**ADDENDUM NO. 1**

**PROJECT NAME:** East Stadium Repairs & Waterproofing, 2012  
**UNL PROJECT NUMBER:** C049P138

**DATE OF ISSUANCE:** April 4, 2012  
**DATE OF BID OPENING:** Tuesday, April 17, 2012

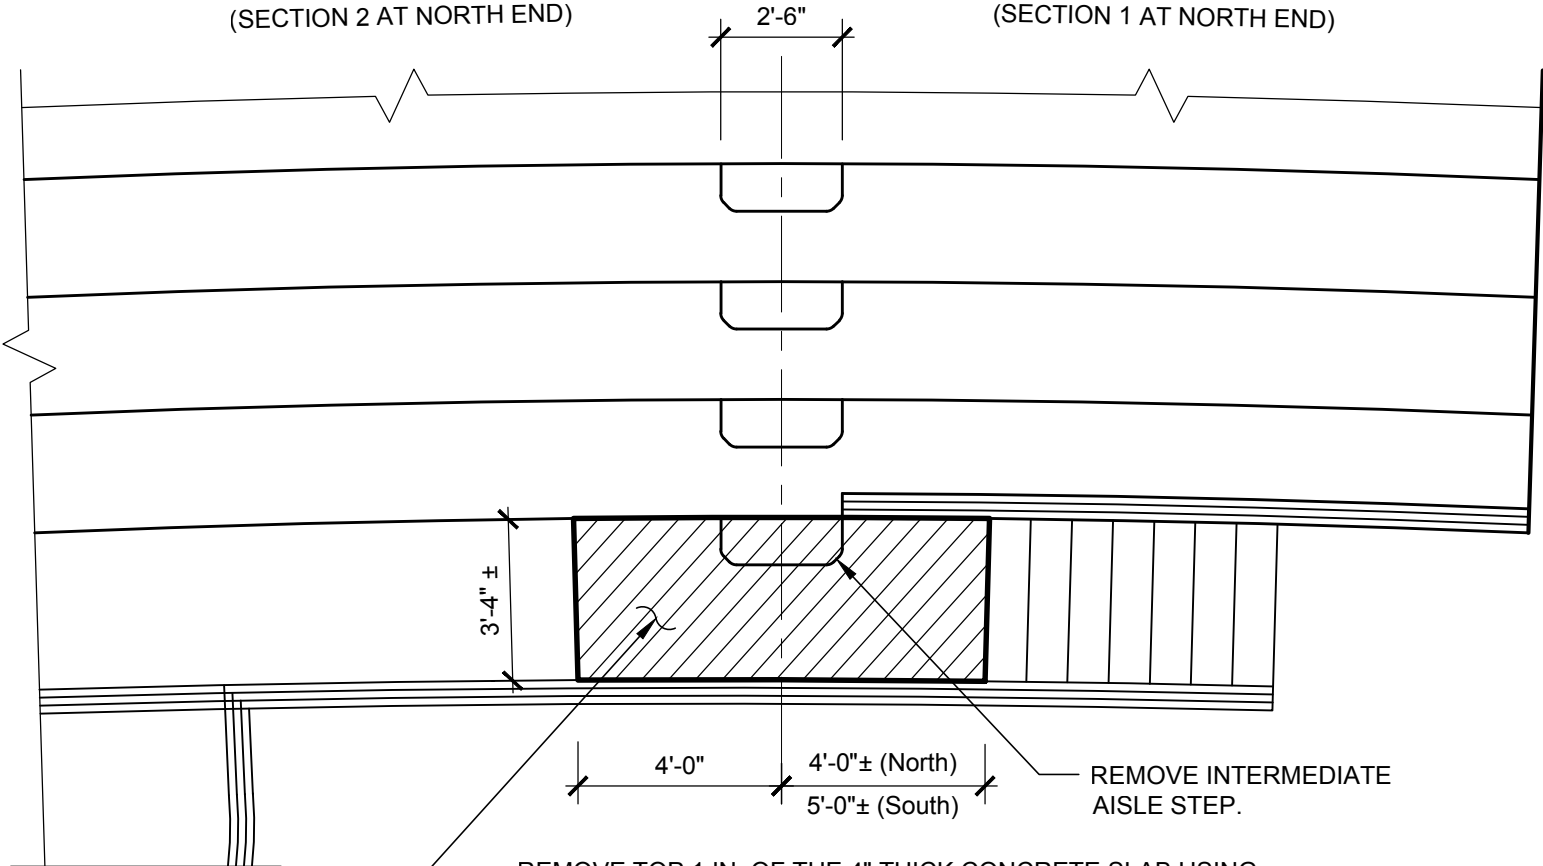
**Item # 5 Add detail SK-1:**

- a. See attached SK-1 detail for concrete top surface repair in Row 1 at the north and south ends of the East Stadium. These repair areas are included in the estimated quantities for Item CR1 "Top Surface Repair" in Table 2 of the Bid Proposal Form.

REMOVE TOP 1 IN. OF THE 4" THICK CONCRETE SLAB USING APPROPRIATE METHODS NOT TO DAMAGE UNDERLYING CONCRETE. DO NOT CUT EXISTING REINFORCEMENT ( $\frac{3}{8}$ " DIAM. AT 6" O.C.). RECAST PER TOP SURFACE CONCRETE REPAIR DETAIL 1/S2.0. ELEVATION OF NEW CONCRETE SURFACE SHALL PROVIDE MAX. 7 IN. STEP HEIGHT AT AISLE, AND SLOPE DOWN UNIFORMLY TO MATCH EXISTING TOP OF SLAB ELEVATIONS AT TOP OF STAIRS, FRONT WALL, AND EDGE OF REPAIR AREA.

C-49-X1

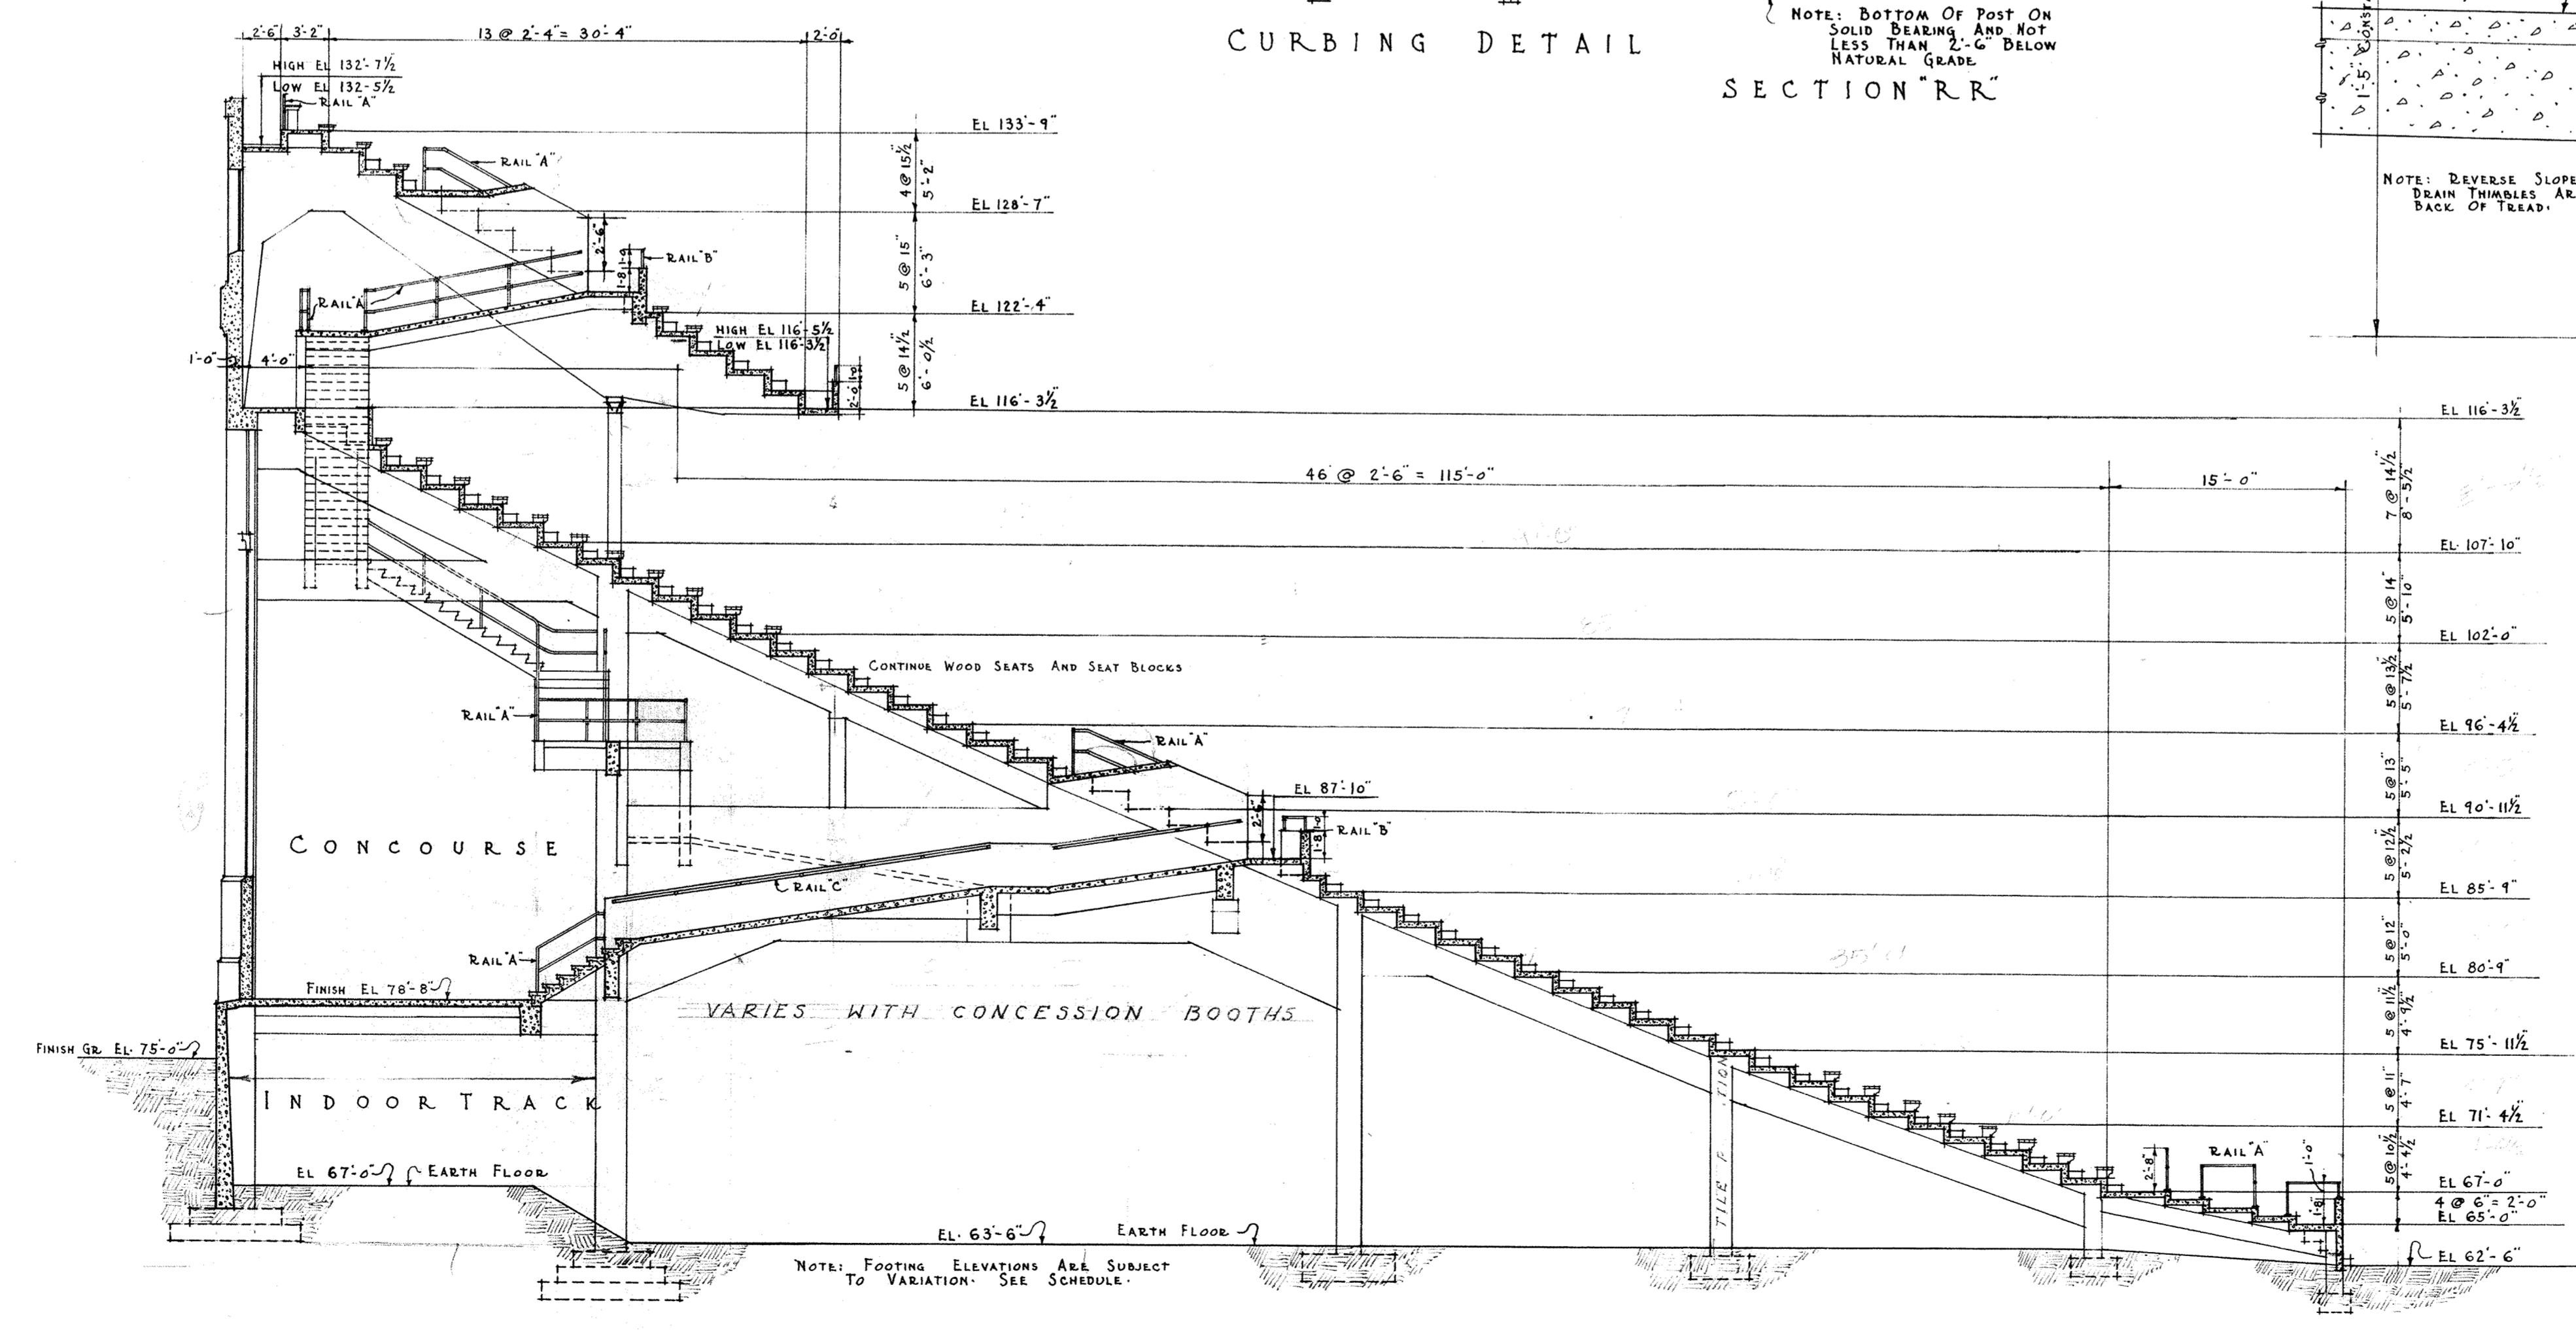
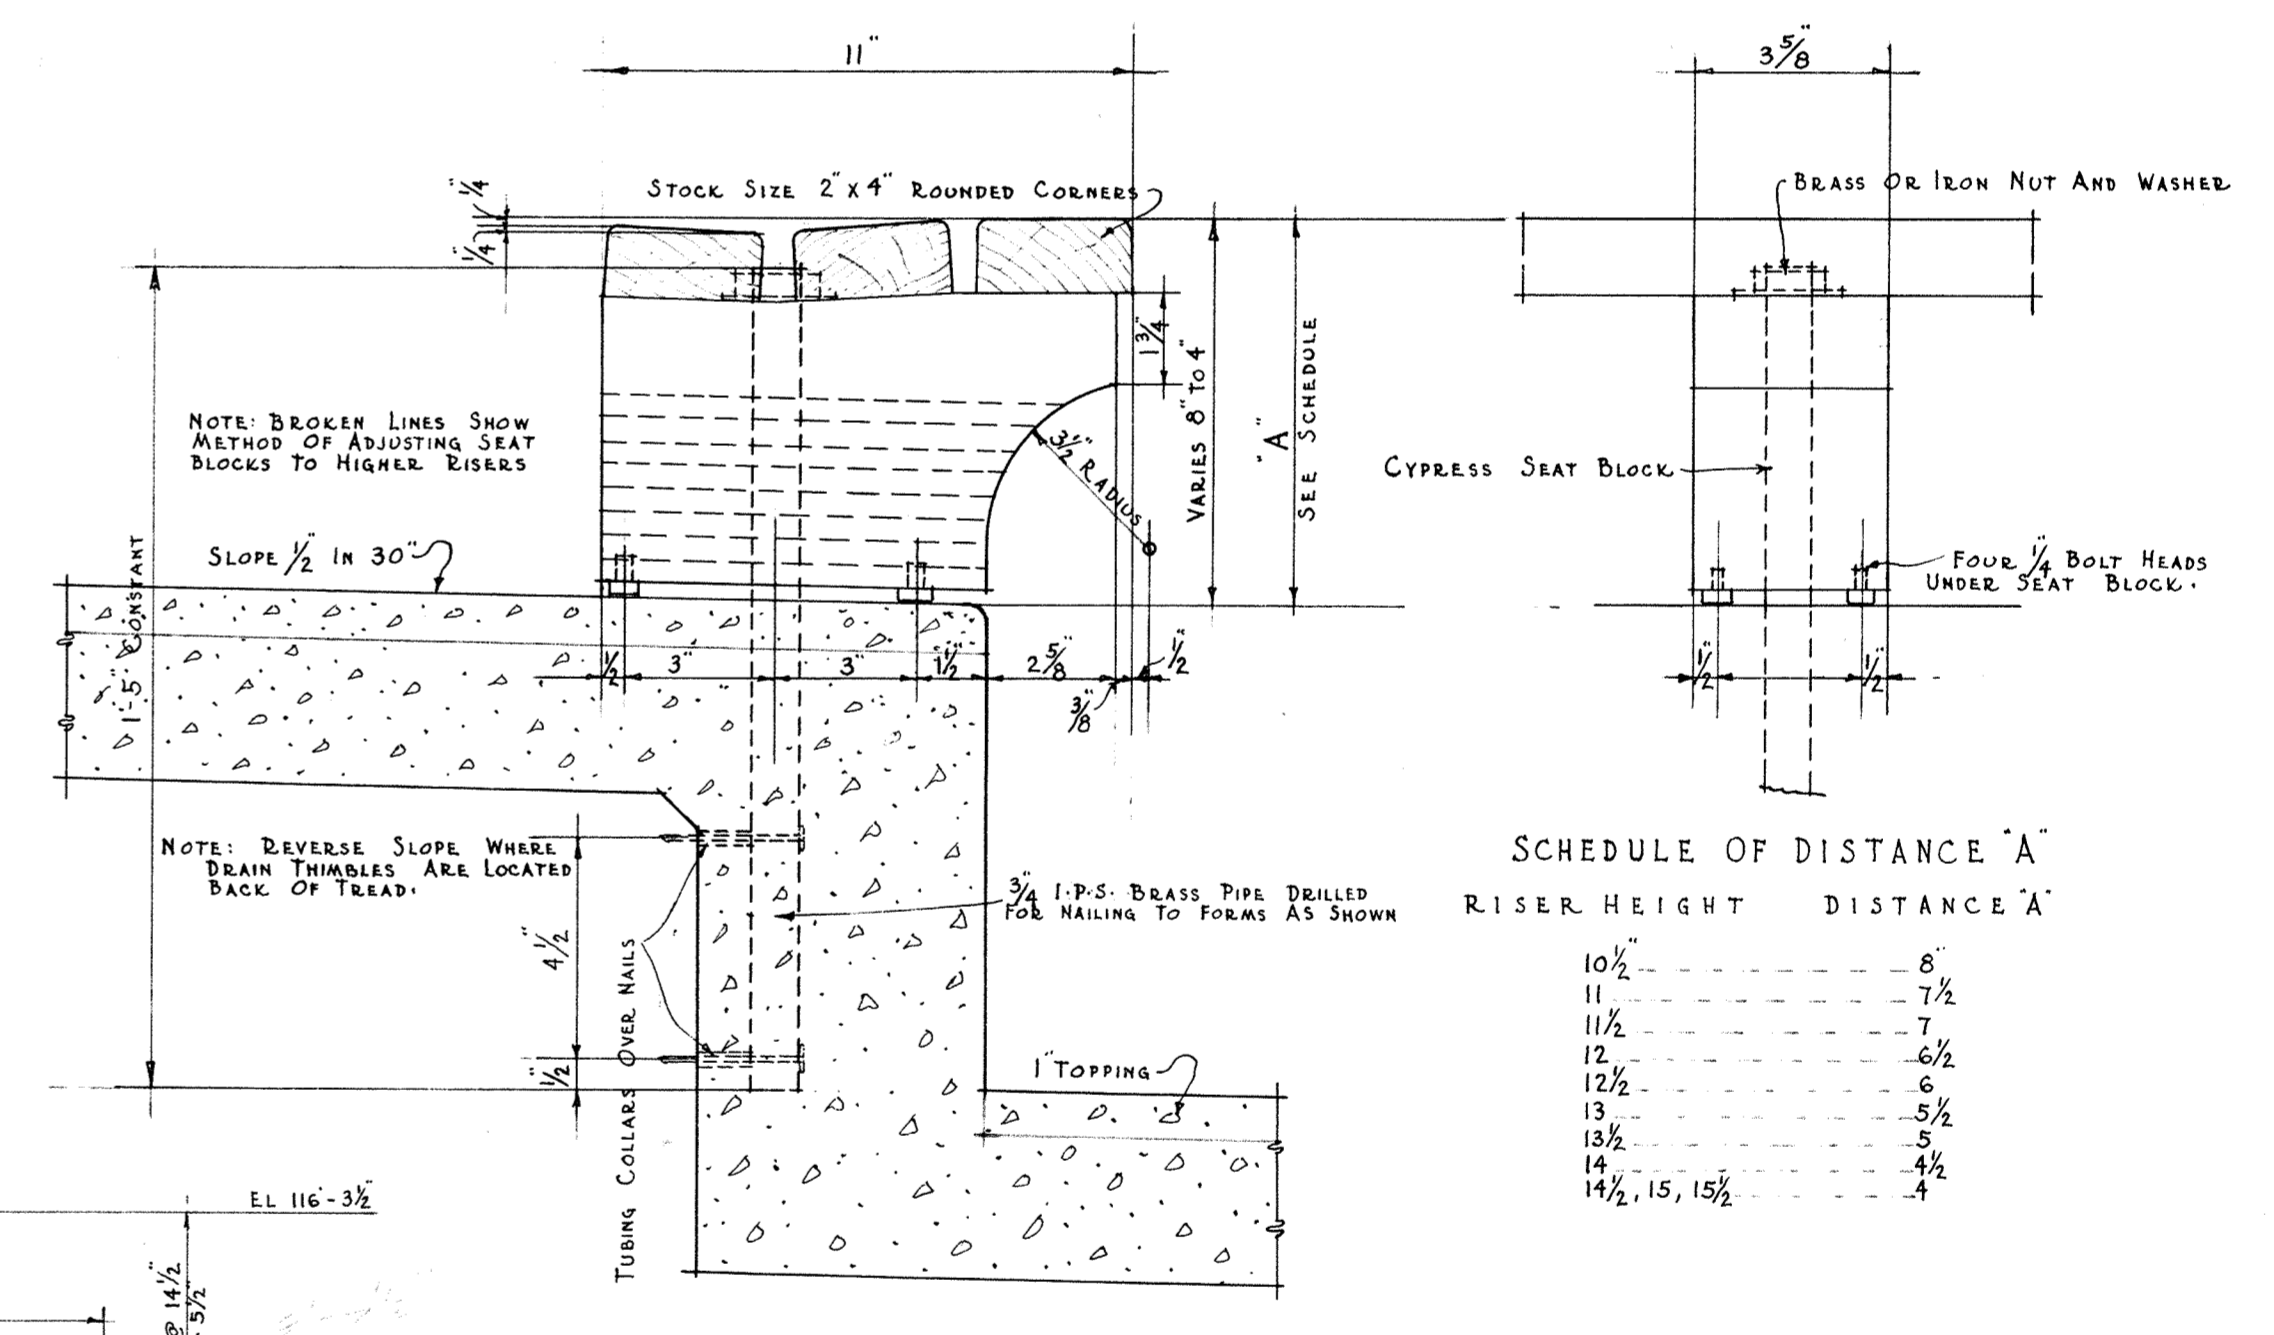
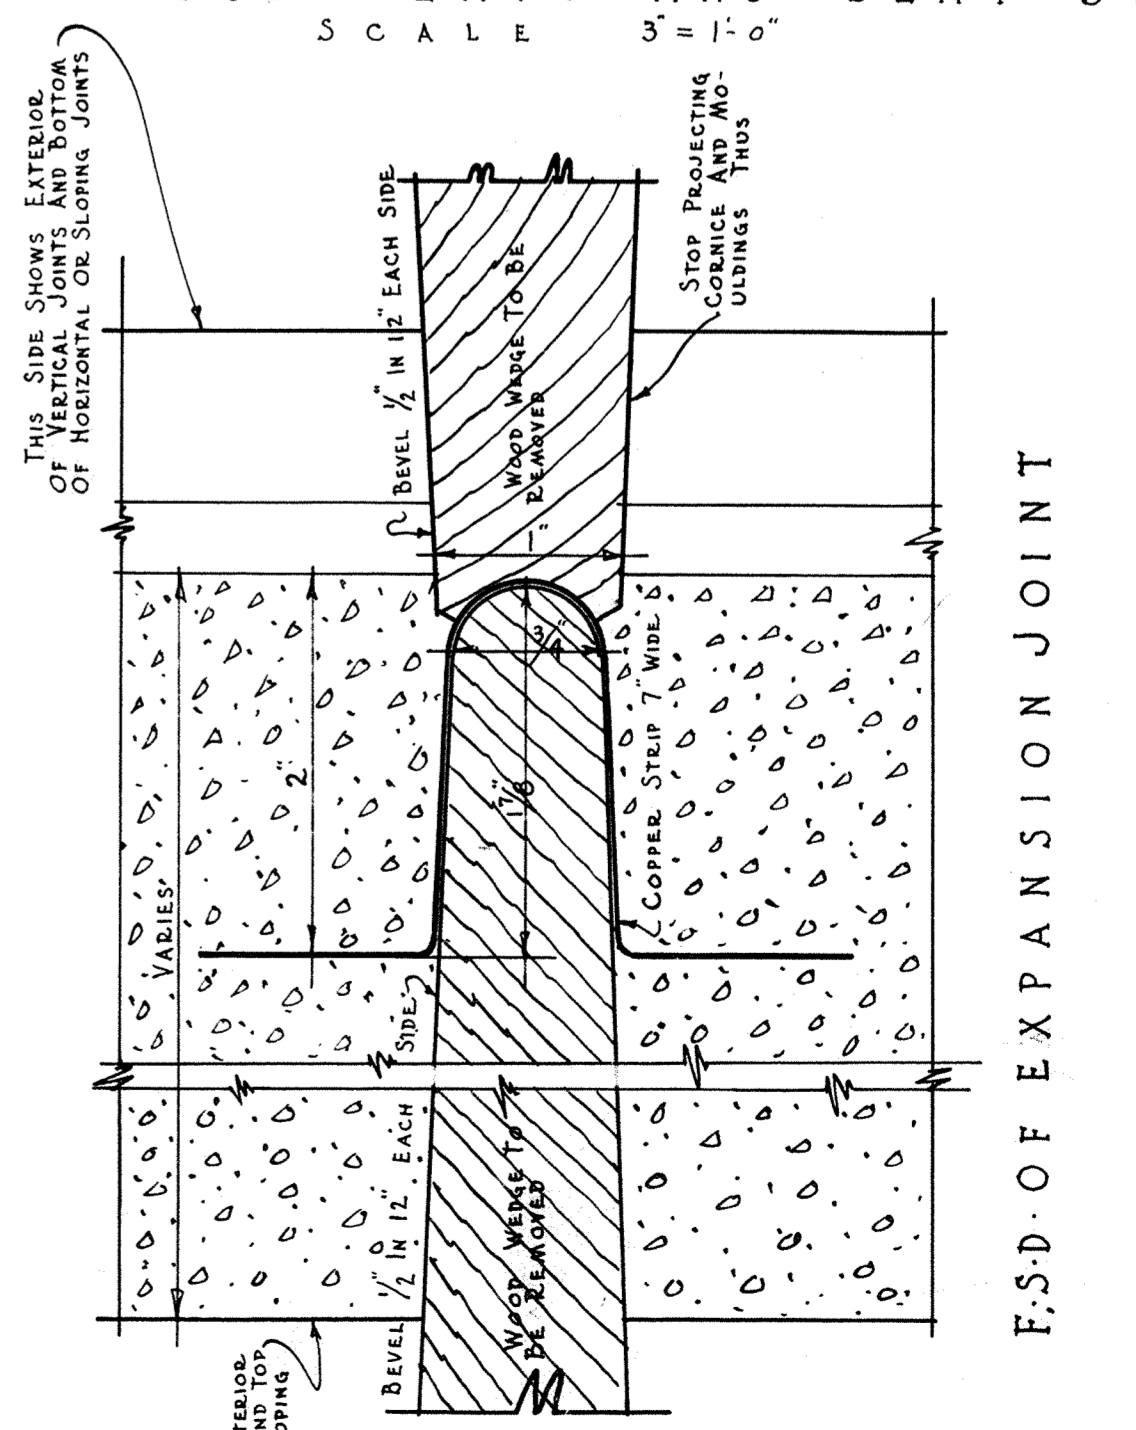
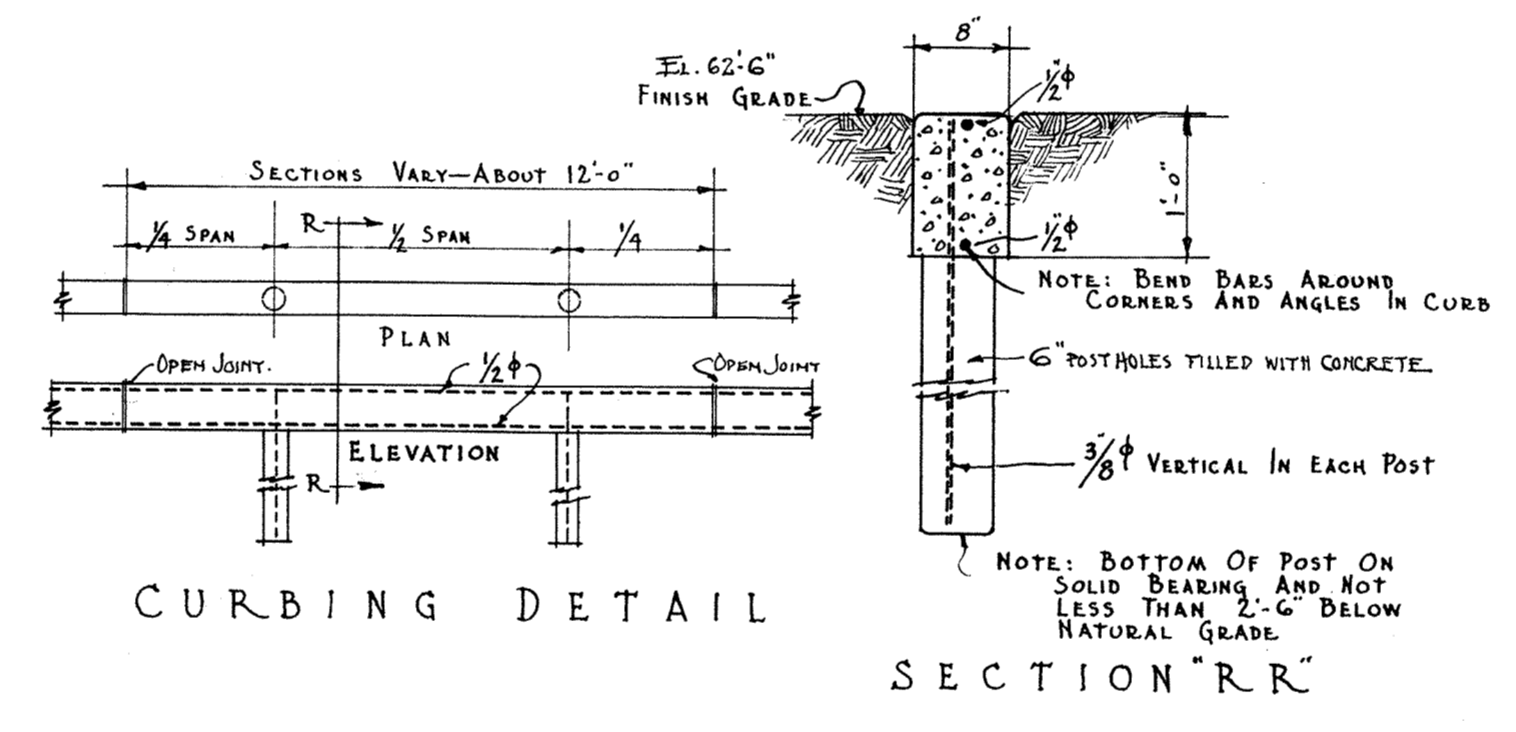
**Item # 7 See the attached, partial, existing building plan:**

- a. See attached plan for general reference. The accuracy and dimensions shown have not been verified by the Owner nor the consultant. The bidder/Contractor is to field verify existing conditions.
